Highlighted difference between Approved Scheme and 'As-Built'/Proposed Scheme

LISTED BUILDING CONSENT				kyson		
Rev: Comments: By: Date:				Studio		
-				28 Scrutton Street London UK EC2A 4RP		
Client: Mr. Simon Dougal				T: +44(0) 20 7247 2462 E: enquiries@kyson.co.uk W: www.kyson.co.uk		
Project Title: 107 High St, Lindfield, Haywards Heath, West Sussex, RH16 2HR				Project No.: 900-25		
Drawing Title: Detail Drawings: Removal of Internal Casement Windows				Drawing No.: 5020		
Scale: 1:25@A1 1:50@A3				Revision: -		
Date: Apr 25						
Drawn: KN						
Checked: KW						
Do not scale this drawing. All dimensions must be checked on site. All rights reserved. No reproduction in any material form is permitted without consent.

Approved Scheme
First Floor Plan
Scale 1:25:A1
1:50@A3

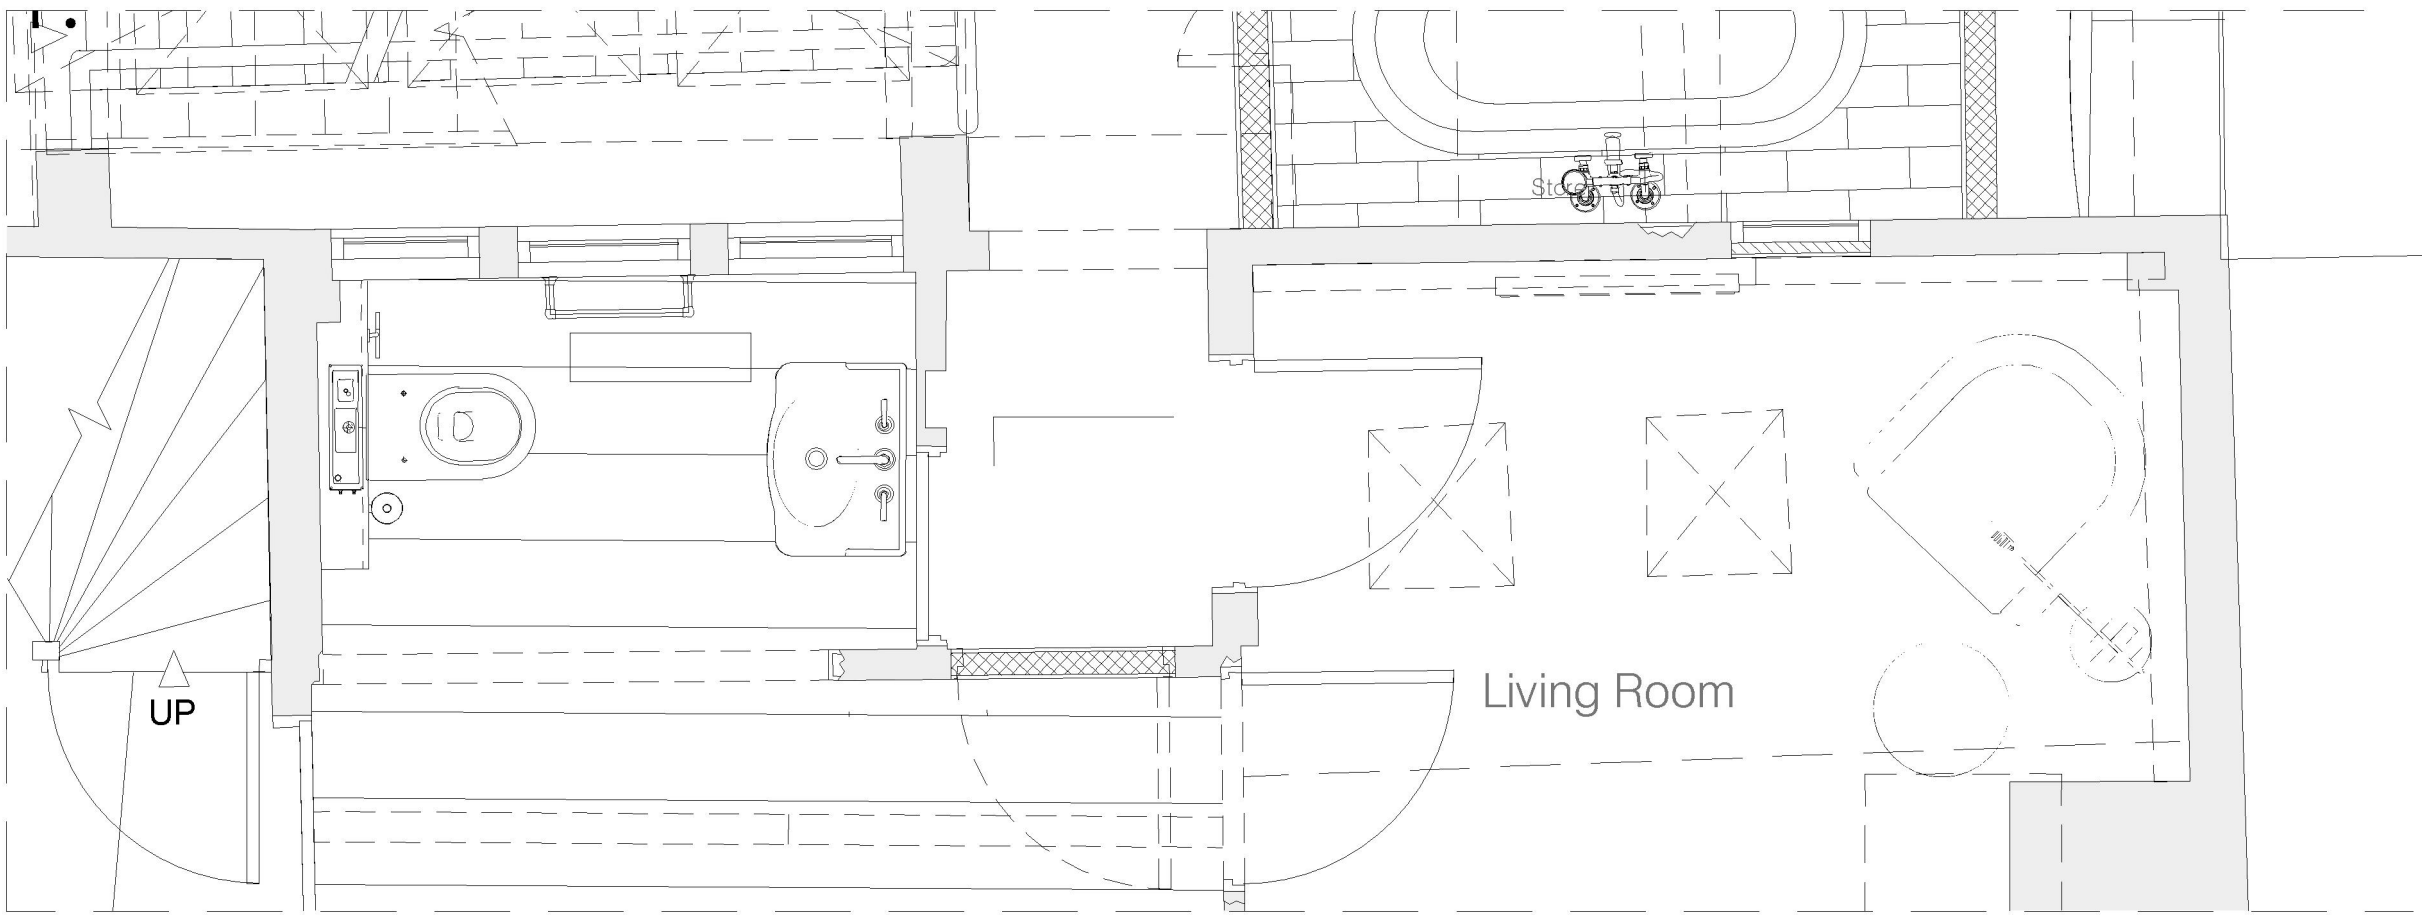
Existing, not original, casement windows to box framing of 15th century west wall removed. Openings filled in with timber stud framing, wood wool boards and lime plaster.

Approved Scheme
Ground Floor Plan
Scale 1:25:A1
1:50@A3

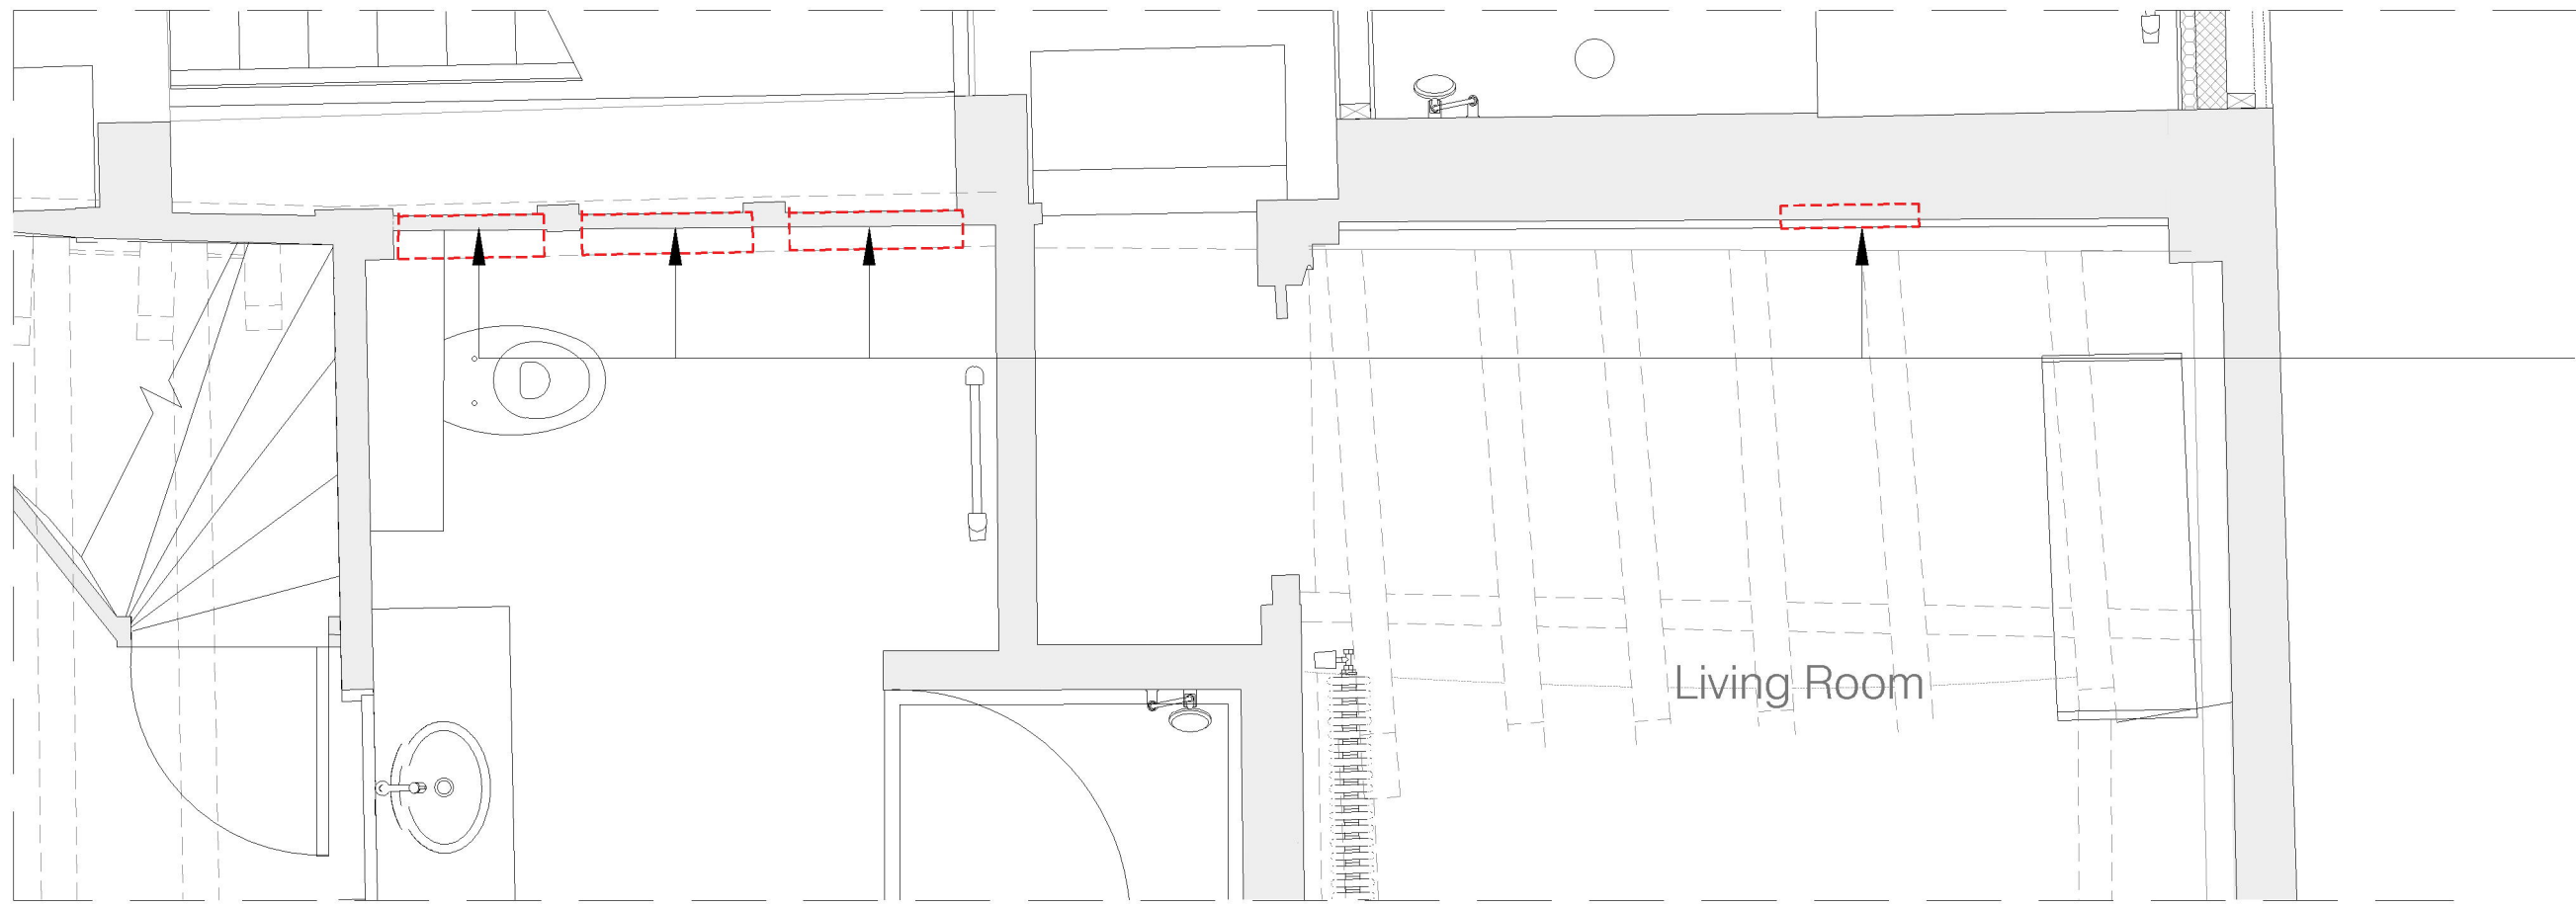
Existing, not original, casement windows to box framing of 15th century west wall removed. Openings filled in with timber stud framing, wood wool boards and lime plaster.
